27 February 2019

Fulton Hogan Ltd  
PO Box 16064  
Hornby  
**Christchurch**

### **Roydon Quarry SDC RFI Transport Matters**

Figure 4-14: Concept Design Option 2

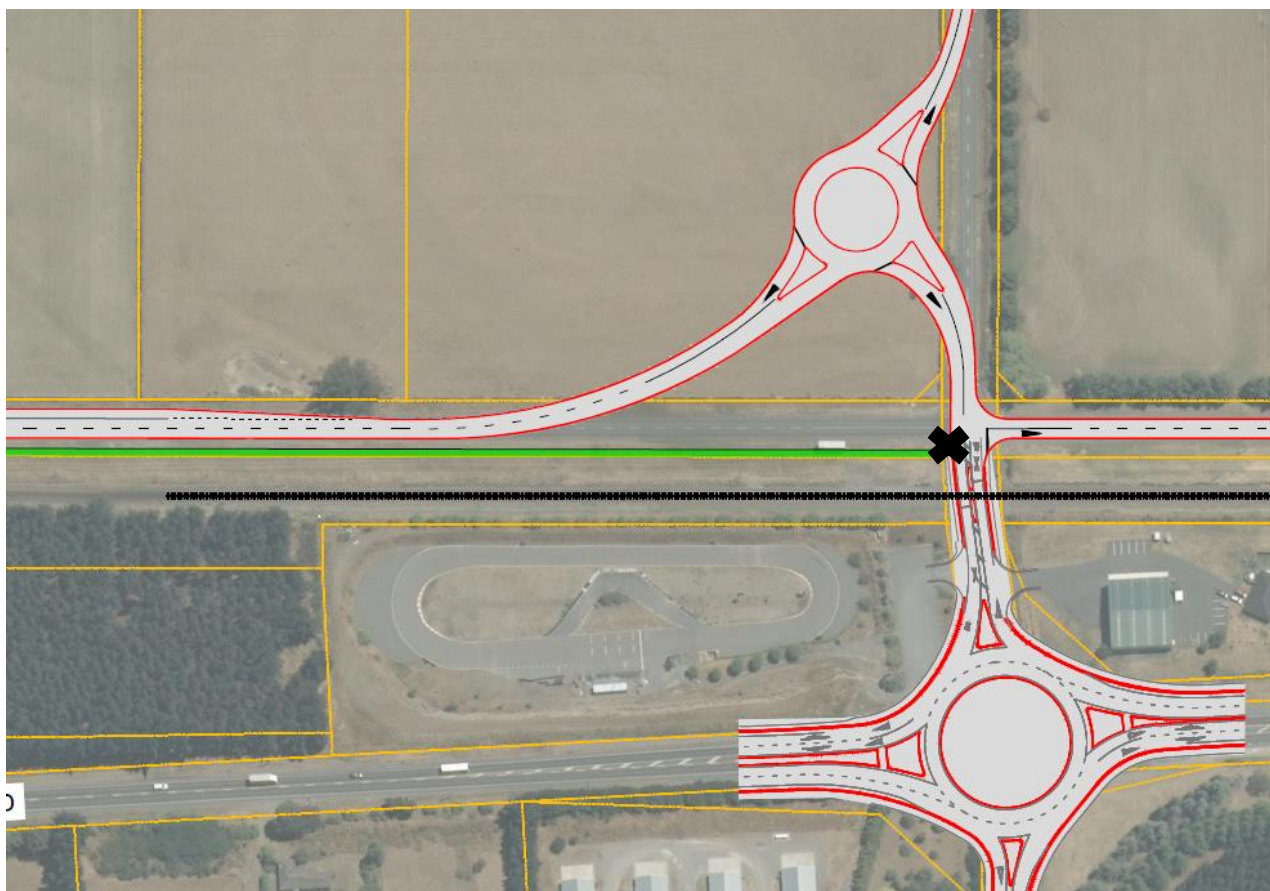
Option 2 has removed the short stacking scenario with Jones Road by moving the new roundabout intersection further north away from the railway line. However, with the eastern leg of Jones Road not relocating to the new roundabout (as the purchase of the land to the north cannot be guaranteed), a new side road has been introduced immediately north of the level crossing.

When an HCV with a trailer waits to turn right onto Jones Road (at the 'X' location in Figure 4-14), their trailer would still foul the railway line as they wait for a gap in the traffic to turn. Therefore, the problem of an HCV fouling the rail corridor has not been fully resolved. If a train was approaching, the waiting HCV would rely on the left-turning traffic (for Jones Road) to reverse the standard traffic priority give way rules and allow the HCV to turn right first to clear the rail corridor. This scenario should not be relied upon as the effective safety solution. A similar problem could arise for a queue of light vehicles, if there are vehicles waiting behind a right-turning vehicle looking for a gap in the opposing traffic flow.

Figure 4-15: Recommended changes to layout of Option 1

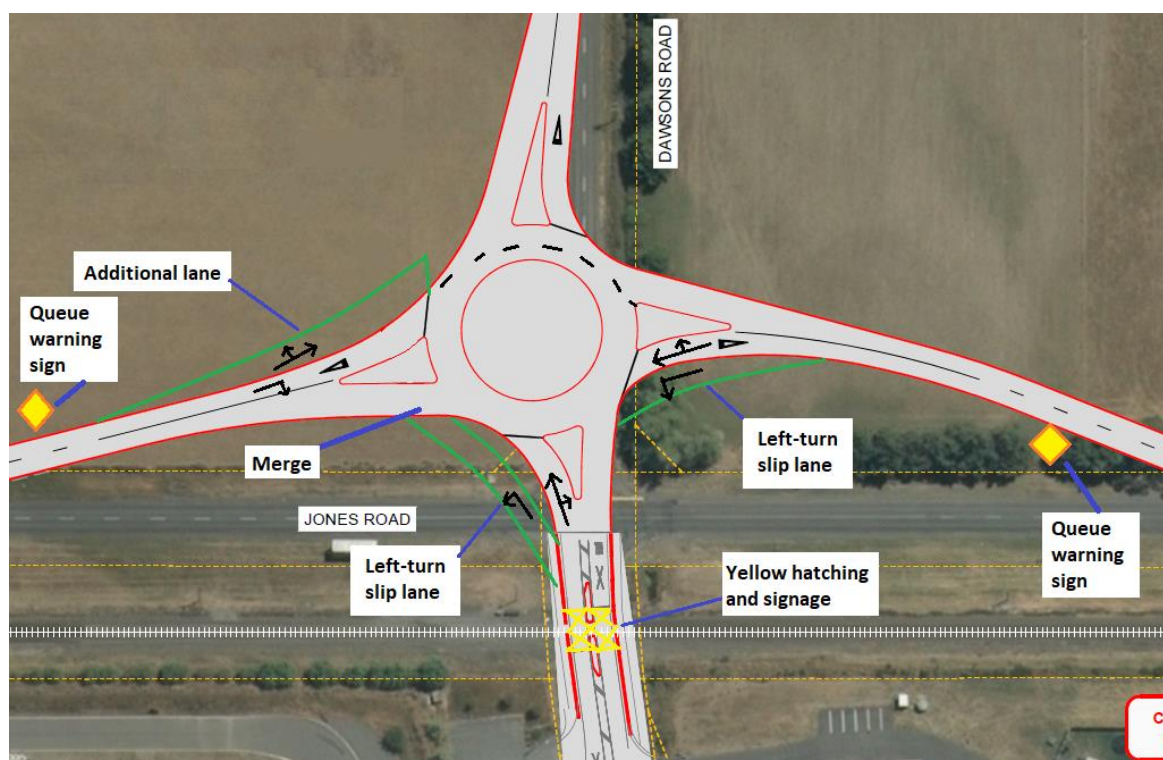
1. Install yellow box hatching and "no stopping" signage at the level crossing.	
For both options there is a possibility of queues forming back over the crossing from the roundabout, much more so with Option 2 than Option 1. As per TCD Pt 9 Figure A12.	TCD Pt. 9
2. Maintenance signage improvements.	
There are some general signage improvements that need to be made by the RCA. These include the intersection advanced warning sign without the railway tracks indicated, the WX1L obscured on the northern approach and the WX1L with lichen growing on it.  An email was sent to the SDC Engineer to highlight these issues, so are not relevant for the applicant to address. In the end, both options would need a range of new signs for the new road layout.	TCD Pt. 9 & Maintenance

- **Left-turn lane on Jones Road eastern approach to roundabout:** Any left-turning vehicles unable to occupy the storage space immediately north of the level crossing, may need to wait at the limit line for the train to clear the level crossing before proceeding. This would block Jones Road through traffic towards Rolleston. Therefore, a left-turn lane may be necessary to keep traffic flowing, but is less important than the additional lane needed on the western approach (given the lower volume of trucks expected from this approach).

- **Advanced warning sign for queue ahead on east and west approaches:** If the additional lanes (above) are deemed unnecessary, it may instead require advanced warning signs for queues ahead installed on the western and eastern approaches. These should be activated by detection loops located back from the limit line.

Figure 4-16: Recommended changes to layout of Option 2

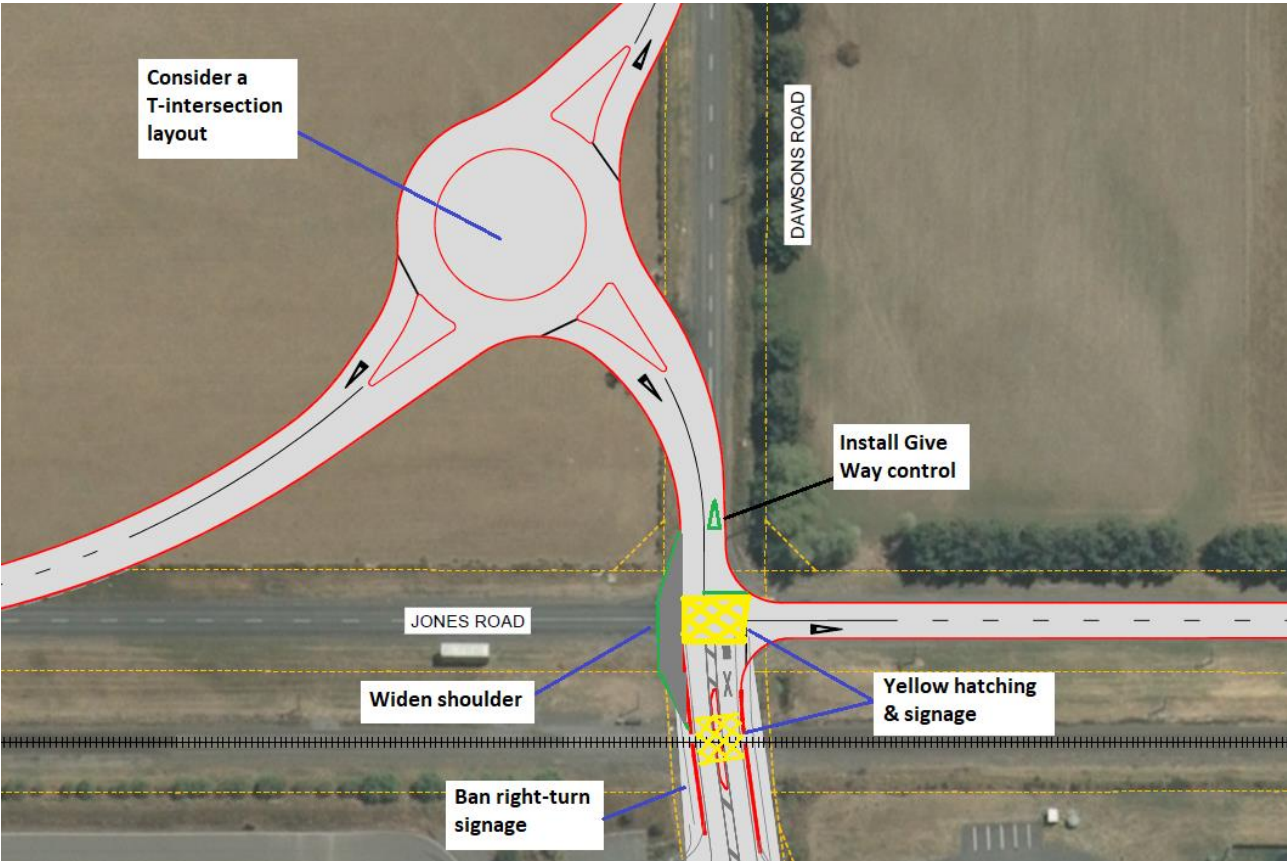
- **Consider changing the proposed roundabout intersection to a T-intersection:** This would put a Stop control on the Dawsons Road northern approach, allowing the Jones Road traffic to flow unimpeded to / from the new T-intersection as shown in Figure 4-16. The alignment of Jones Road would follow a similar curvilinear alignment as shown in Figure 4-16, just without the roundabout control.

- This would then minimise any possibility of queues forming back from the roundabout over the level crossing if this was shown to be an issue during peak hour traffic. Although Option 2 provides more storage capacity by moving the roundabout further away from the level crossing, the queue on this approach is the combination of Jones Road traffic (from Templeton) and Dawsons Road traffic from the level crossing (the queue issues in Option 1 consists of Dawsons Road traffic only). The Give Way recommended on Dawsons Road would still need to be in place, so Dawsons Road traffic turning right onto Jones Road (immediately after the level crossing), still has priority as not to form a queue back over the level crossing.

- This option would need to consider whether a safe design can be built without speed management around the curvilinear horizontal alignment in the road. It would be a tight radius curve, so the speed of vehicles approaching from the west may cause a safety issue.
